Informal document GRPE-85-02e 85th GRPE, 11-14 January 2022 Agenda item 3(a)

Proposals for Future UNR154 Amendment

prepared by JAPAN

Observation 1

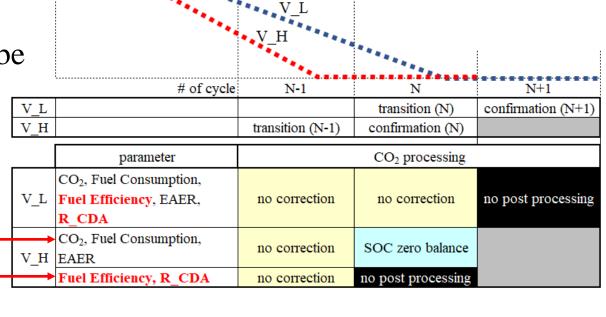
Under the current provision_A, two (2)

different CO₂ for V_H condition need to be

calculated according to parameter.

Without the current provision(A), identical value is expected theoretically.

Observation 2

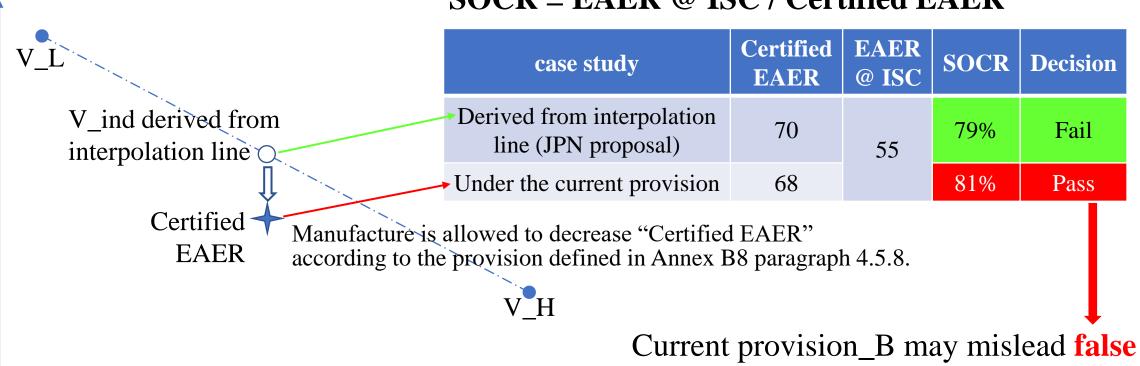
When apply current provision(A) during ISC under EVE GTR, EAER value may be over-evaluated and it misleads false pass. Case study (in case of N=5)

Current provision_B may mislead false pass under SOCR requirement with few disadvantage for manufacture
